RESOLUTION NO. R-2024-171

A RESOLUTION OF THE CITY COUNCIL OF THE CITY OF BASTROP, TEXAS APPROVING CHANGE ORDER #1 TO THE CONSTRUCTION CONTRACT WITH BAR CONSTRUCTORS, INC. FOR THE CONSTRUCTION OF THE REDESIGNED STORMWATER OUTFALL STRUCTURE AS PART OF THE WASTEWATER TREATMENT PLANT #3 PROJECT FOR A NOT TO EXCEED AMOUNT OF TWO HUNDRED SEVENTY-TWO THOUSAND, TWO HUNDRED NINETEEN DOLLARS AND FORTY-NINE CENTS (\$272,219.49); AUTHORIZING THE CITY MANAGER TO EXECUTE ALL NECESSARY DOCUMENTS; PROVIDING FOR A REPEALING CLAUSE; AND ESTABLISHING AN EFFECTIVE DATE.

CHANGE ORDER NO. 01

Bastrop WWTP No. 3 Contract Name: Bastrop WWTP No. 3

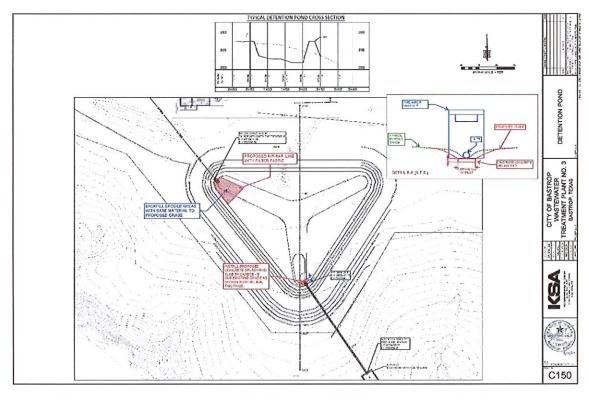
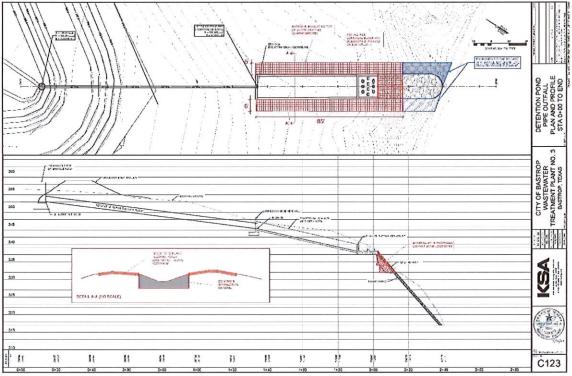
Ħ	Product or service	Description	Qty	Rate	Amount
1.	Mobilization	Mobilization of needed Equipment and Materials	1	\$4,734.00	\$4,734.00
2.	Erosion Repair	Pipe Outfall Repair Includes the Installation of Flexamat, Riprap With 8oz Filter Fabric, and Stabilized Flex base per Plans Received 5-2-24	1	\$158,823.49	\$158,823.49
3.	Detention Basin Repair	Detention Pond Repair Includes Installation of 12' Riprap with Filter Fabric over base backfill at Inflow Structure 1 and Installation of concrete pad at Discharge Inlet per plans received 5-2-24	1	\$15,963.53	\$15,968.53

BAR 169 9235
9/31/3024
Cost Proposal GAA
Stormwater Outfall Redesign - Unforseen
Conditions

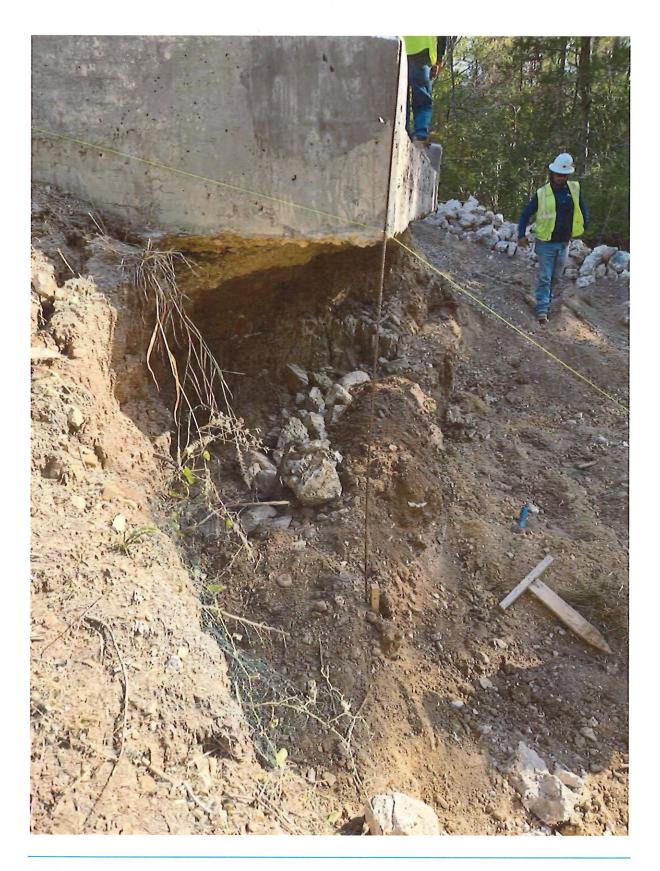
Cost Proposal 044A Stormwater Outfall Redesign - Unforseen Conditions														
			Material/Subj	Eq./p Credit	Labor	redt	Libor	Cost	Meteri		Equipm			actor Cost
Description	City	Unit	Unit Cost	Total	Unit Cast	Total	Unit Cost	Total	Unit Cost	Total	Unit Cost	Total	Unit Cost	Total
Uniforseen Conditions under Dispator Slab and additional Rip					•			•					•	
Rip	100	IS											14,725.15	14,725.15
